**STAFF REPORT:** 03/13/2024 MEETING

**APPLICATION NUMBER:** HDC20204-00047

**ADDRESS:** 2900 ST. ANTOINE STREET (637 BREWSTER)

**SCOPE OF WORK:** INSTALL WINDOWS, REMOVE ENTRY CANOPY\*

#### Remove Entry Canopy

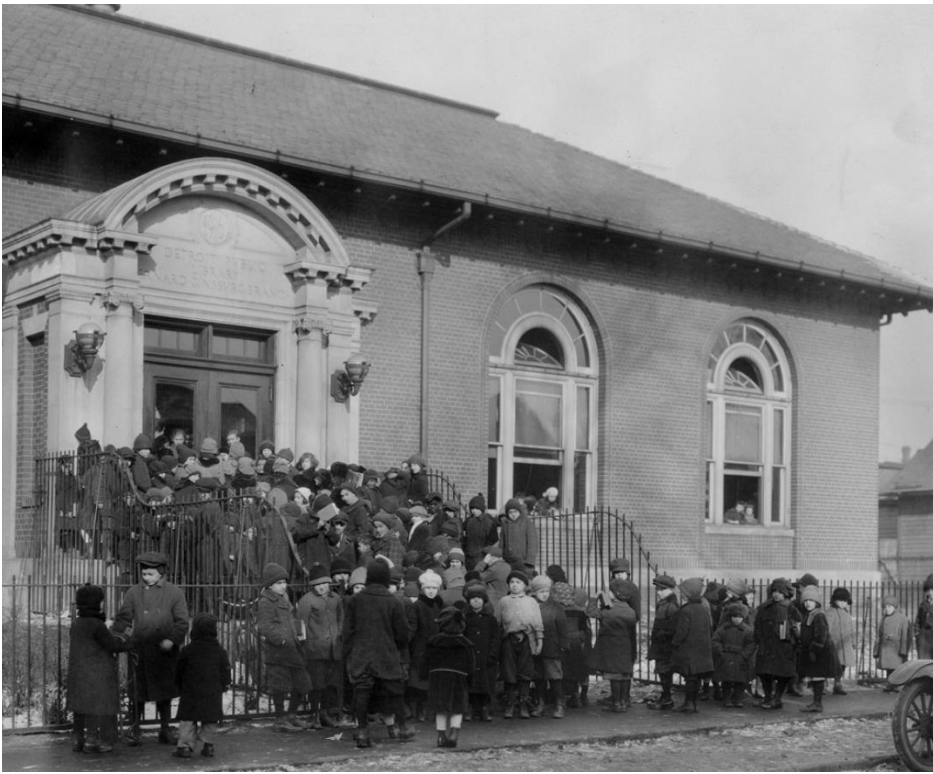
A limestone clad canopy was added over the original wing's primary entrance in 1967. The applicant is seeking to demolish this canopy. Note that they have recently removed the limestone cladding without HDC approval and/or permit, leaving only the steel framing. The stone steps at this entrance will be retained. Where damaged beyond repair, the stone steps will be replaced in kind. New steel handrails will also be added at this entrance.

**2900 St. Antoine, flat roof canopy prior to the unapproved limestone cladding removal. Photos provided by applicants**

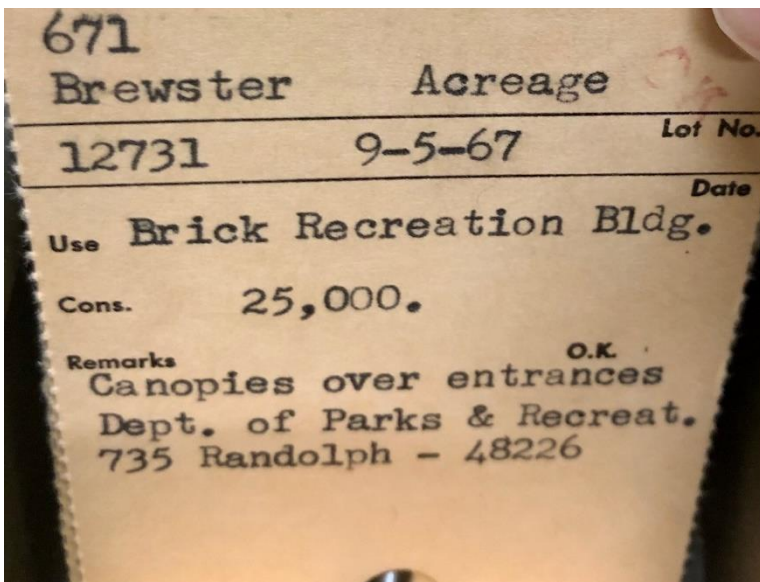
- Staff therefore recommends that the building's Period of Significance begins in 1917, which is the date of the building's original construction, and ends in 1955, the date the last building within the Brewster Douglass neighborhood was completed.
- As previously noted, the applicant removed the limestone cladding from the flat-roofed canopy that is located at the original building's south façade primary entry without HDC approval and/or permit, leaving only the structure's steel frame. With the current application, they are seeking approval to remove the structure/canopy in its entirety. Per the submitted information, the limestone cladding was removed due to its deteriorated condition. Staff did research the age of the canopy and found that it was installed in 1967 (see below image). As the canopy was

erected after the building's suggested Period of Significance, staff does find that its removal does meet the Secretary of the Interior's Standards for Rehabilitation.

**2900 St. Antoine, facing southeast. Photos taken by staff on 2/27/2024**

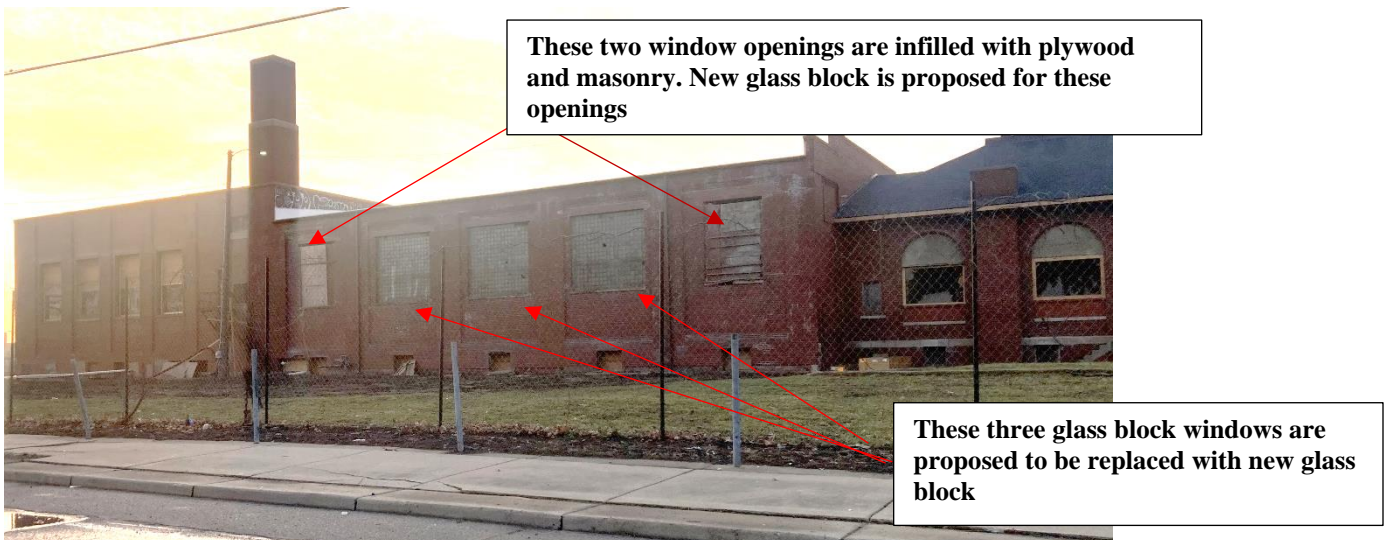
- The proposal is seeking to replace the three existing glass block windows at the building's north elevation with new glass block. Glass block is also proposed for the two flanking window openings, which are currently infilled with plywood and masonry (see below photo).

- Glass block walls and windows are typical to Streamline Moderne and Art Deco buildings of the 1930s and 1940s. However, note that the material was typically employed intentionally as a decorative/design element to emphasize rounded edges and corners. While the 1929 addition is Art Deco in style, the glass block found at the north elevation window openings is likely not original to its date of construction as appears as a utilitarian element employed to affordably enclose a large opening. It is possible that the glass block window infill is of historic-age, however staff was unable to find any evidence that it was added during the building's period of significance. It is therefore staff's opinion that the current glass block is not compatible with the building's historic appearance.

- Although not compatible with the building's historic appearance, the north elevation glass block was present at the time of the property's designation. Therefore, retaining the incompatible existing glass block and undertaking minor repairs/routine maintenance where necessary meets the Secretary of the Interior's Standards for Rehabilitation as it is a condition that existed at the time of designation. However, if these incompatible windows are proposed for removal, the new replacement windows must be compatible with the building's historic character per the National Park Service's (NPS) brief entitled *Replacement Windows that Meet the Standards*, which notes that "replacing existing incompatible, non-historic windows with similarly incompatible new windows *does not meet the Standards*" [Replacement Windows that Meet the Standards - Historic Preservation Tax Incentives \(U.S. National Park Service\) \(nps.gov\)](#) The NPS further states that "replacement of missing or non-historic windows must, however, always fill the original window openings and must be compatible with the overall historic character of the building. The general type of window – industrial steel, wood double-hung, etc. – that is appropriate can usually be determined from the proportions of the openings, and the period and historic function of the building. The appearance of the replacement windows must be consistent with the general characteristics of a historic window of the type and period, but need not replicate the missing historic window. In many cases, this may be accomplished using substitute materials." It is HDC staff's opinion that the proposed installation of glass block at the building's north elevation does not meet the Secretary of the Interior's standards for Rehabilitation.

- The glass block that is currently located at the building's north elevation is not compatible with the building's historic appearance. If these incompatible windows are proposed for removal or if plywood and masonry infill at this elevation is proposed for removal, the new windows must be compatible with the building's historic character per the National Park Service's (NPS) brief entitled *Replacement Windows that Meet the Standards*, which notes that "replacing existing incompatible, non-historic windows with similarly incompatible new windows *does not meet the Standards*. Therefore, new glass block shall not be installed within the building's north elevation window openings. The applicant shall provide a proposal for compatible/appropriate new

windows to HDC staff for review and approval prior to issuance of the project's permit. Should staff determine that the work does not meet the Standards, the project shall be forwarded to the Commission for review at a future regular meeting.
